19.7-03

### Knocking from Front Suspension – Shock Absorber Mounting – Repair Procedure

MODEL 1995-96 MY  
Sedan Range  
VIN  
720001-ON

ILLUSTRATION 1

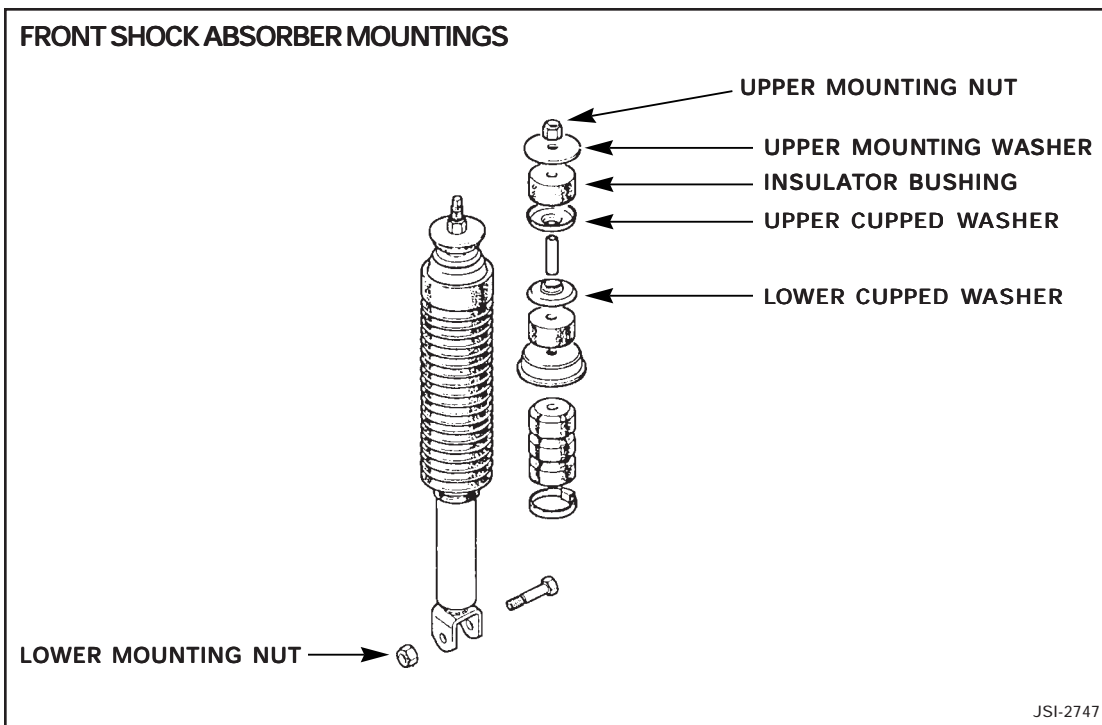
2. Check that the shock absorber upper cupped washer (Illustration 1) is fully seated against the inner fender panel in the engine compartment.
3. Remove the upper mounting nut (Illustration 1) and remove the upper mounting washer and insulator bushing.
4. Inspect the cupped washer. If the washer is distorted or damaged in any way, install a new cup washer (part no. CBC 5431). Reassemble the bushing and cup washer, ensuring that the cup washer is correctly seated against the body. Always install a new nut (part no. JZN 100013) and torque to 26 lb. ft. (35 Nm).
5. Repeat steps 1-4 on the opposite side of the vehicle.
6. Reinstall components removed in step 1.

ILLUSTRATION 2

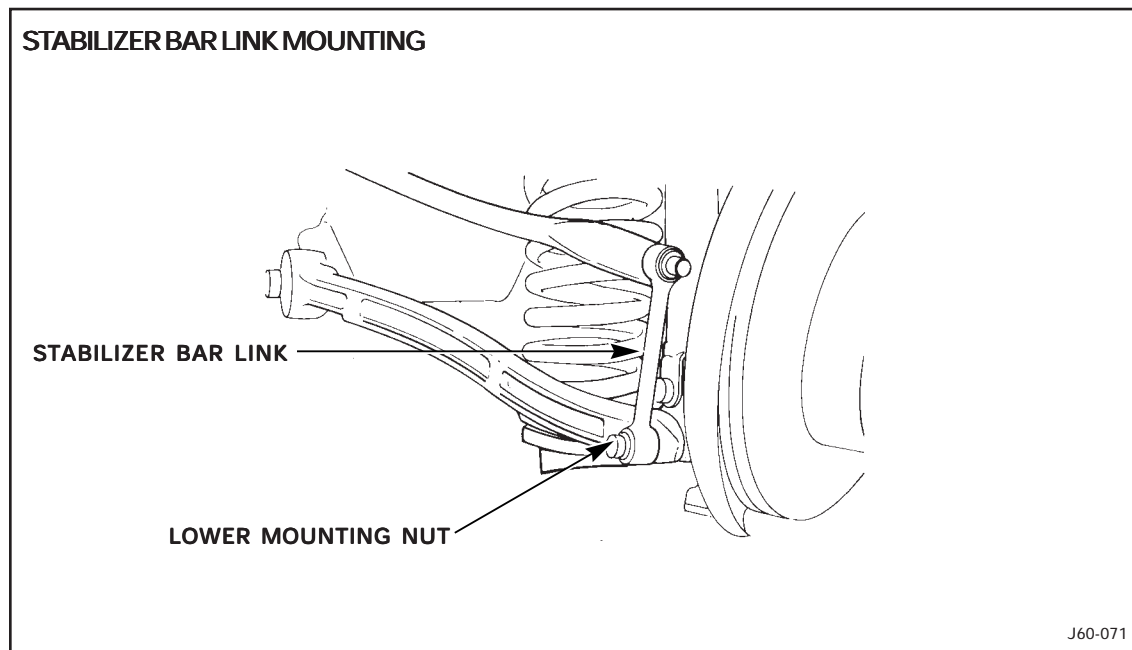
1. After performing the above inspection, raise the vehicle on a lift so the front suspension hangs fully extended.
2. Remove the mounting nut (Illustration 2) from the lower mounting of the stabilizer bar link. Discard the nut. Move the link aside to allow access to the lower mounting of the shock absorber.
3. Remove and discard the existing lower mounting nut (Illustration 1) from the lower mounting bolt of each shock absorber.
4. Install a new mounting nut (part no. JZN 100013) and torque to 51.6 lb. ft. (70 Nm).

5. Reinstall the stabilizer bar link using a new nut (part no. JZN 100013) and torque to 70 lb. ft. (95 Nm).
6. Repeat steps 1-5 on the opposite side of the vehicle.
